ADDENDUM NO. 3

DATE: September 21, 2017
TO: All Bidders
FROM: ~~Boyce~~ H. Evans, Purchasing Agent
SUBJECT: Addendum No. 3 – North Central Street Streetscapes Project
BIDS TO BE OPENED: September 27, 2017, at 11:00 a.m. (Eastern)

STREETSCAPE IMPROVEMENTS
NORTH CENTRAL STREET
KNOXVILLE, TENNESSEE

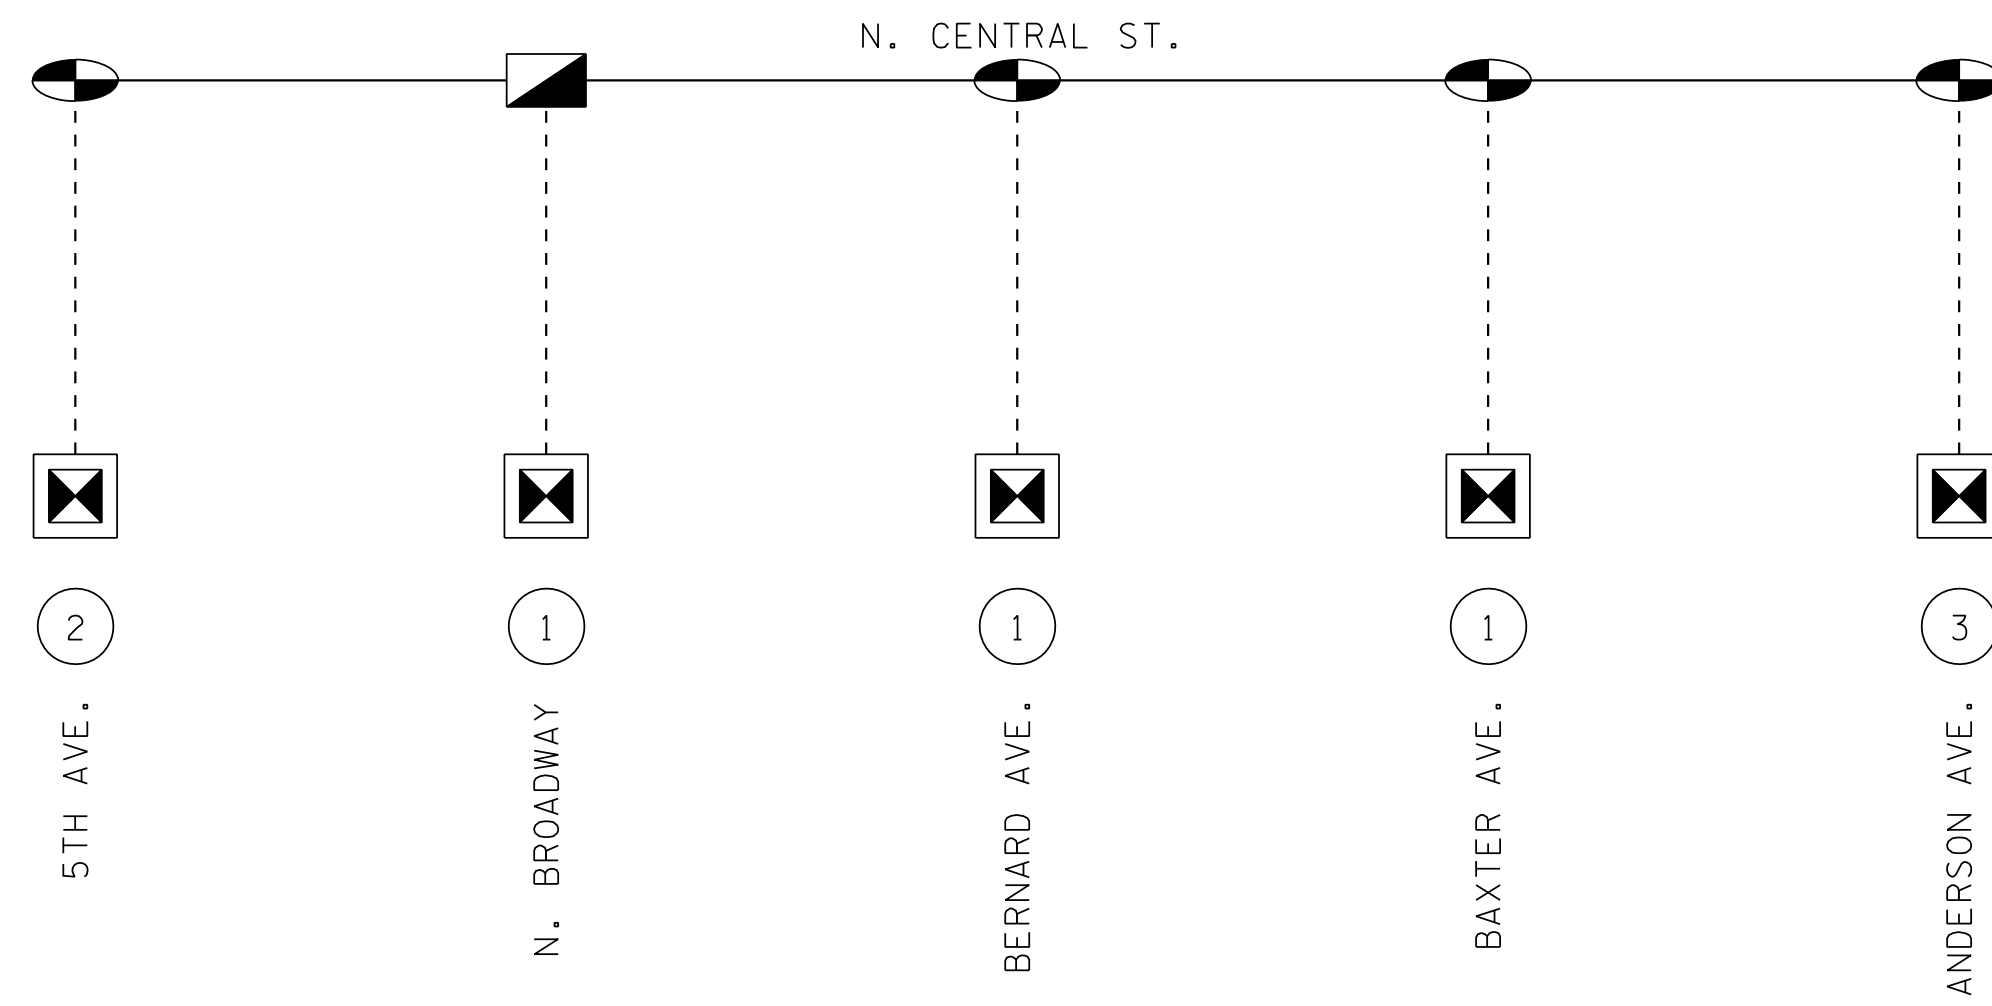
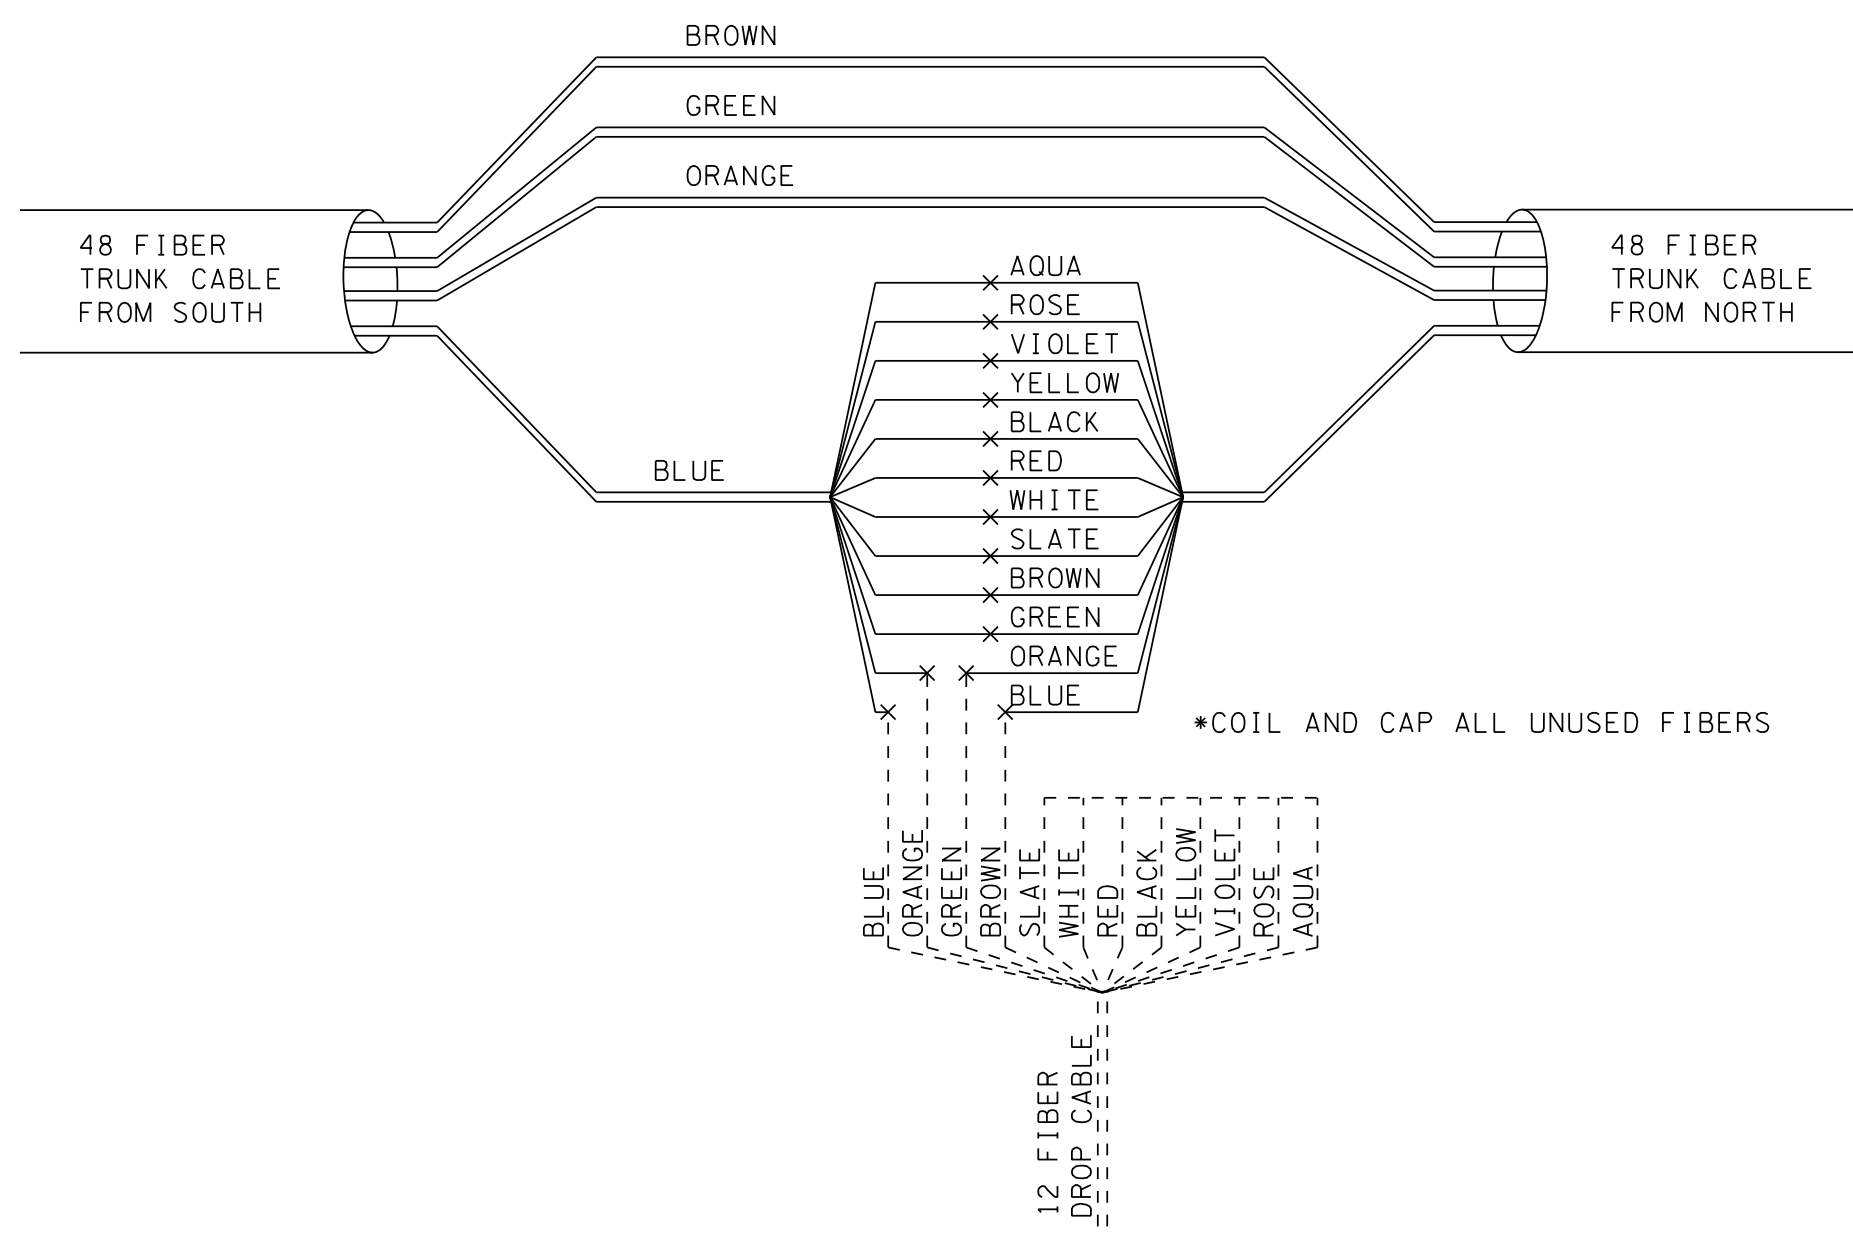
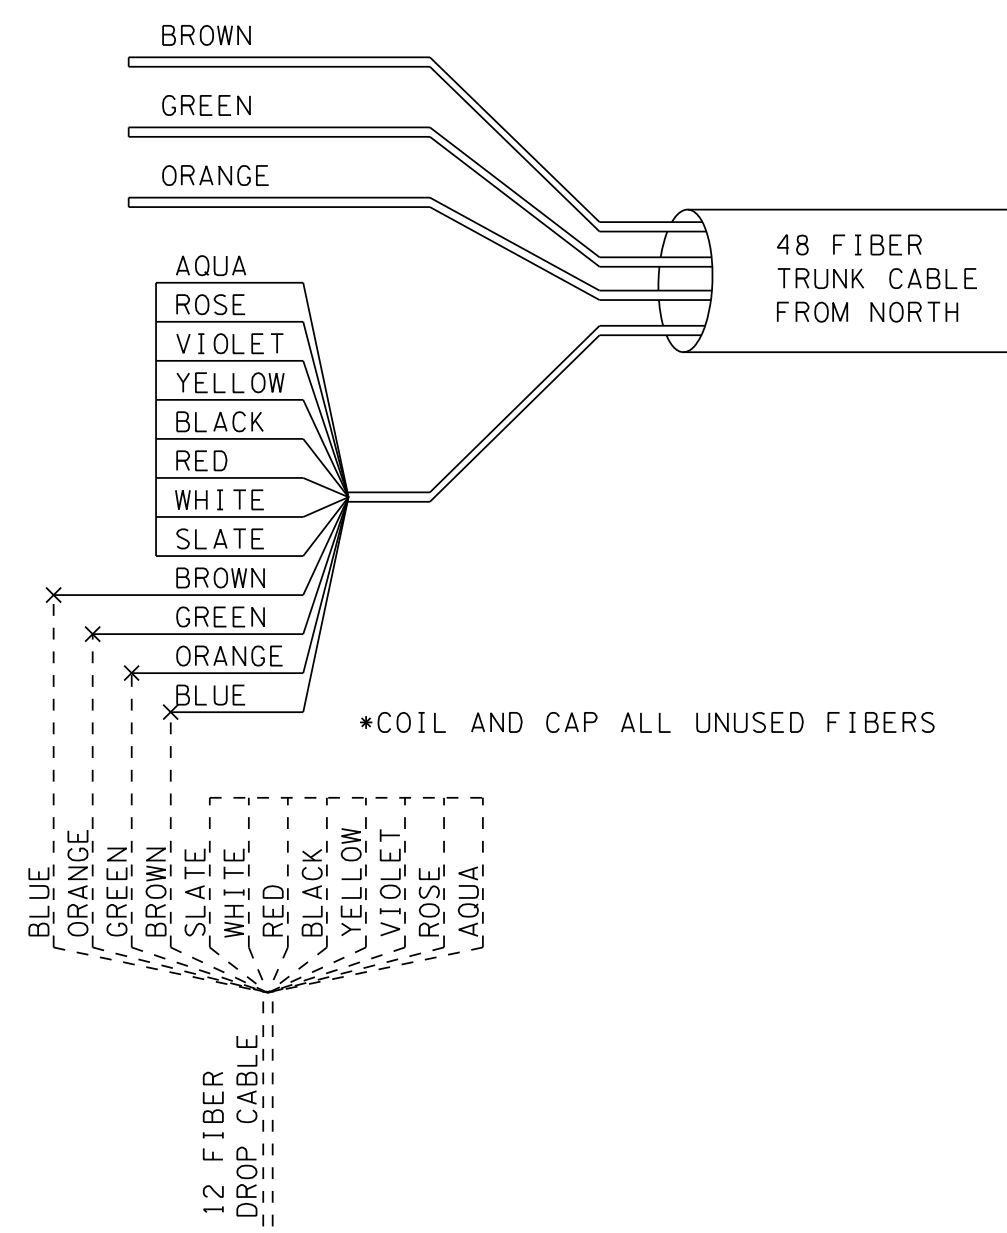
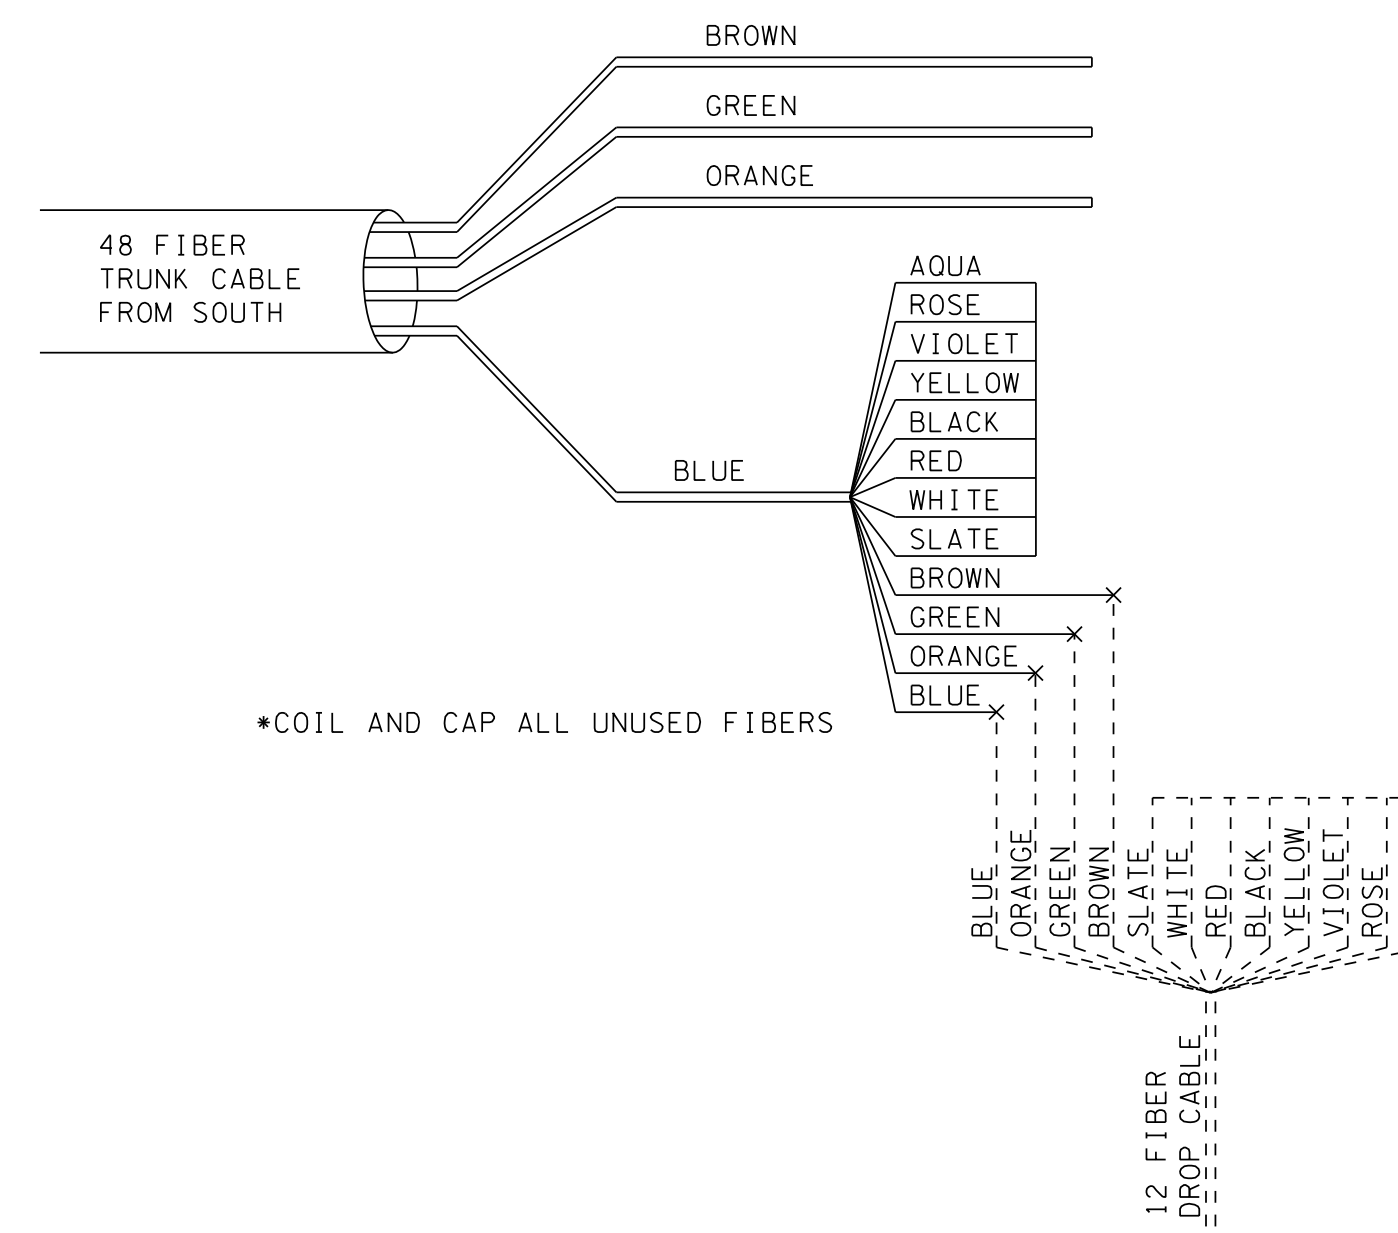
Question #2: How are the fiber optic splices figured? Plans show 5. Fiber is 48 strands and there would be many, many more than 5.

Response #2: Sheet TS6.06 has been added to the plans, which shows various fiber splicing details for each intersection. For the pay item, per pages 58 and 59 of the City of Knoxville's Special Provision Section 730K – Traffic Signals, and the added footnote on the Estimated Quantities Sheet, the pay item shall be per each fiber splicing location. Therefore, the quantity will remain at 5.

- INCLUDES FOUNDATION.
- INCLUDES 2'-2' DASHED WHITE LINE ON SIDES OF GREEN BARS WITHIN INTERSECTIONS.
- INCLUDES ALL FUSION SPLICES REQUIRED IN A SINGLE SPLICE ENCLOSURE. SEE SHEET TS6.06 FOR DETAILS.
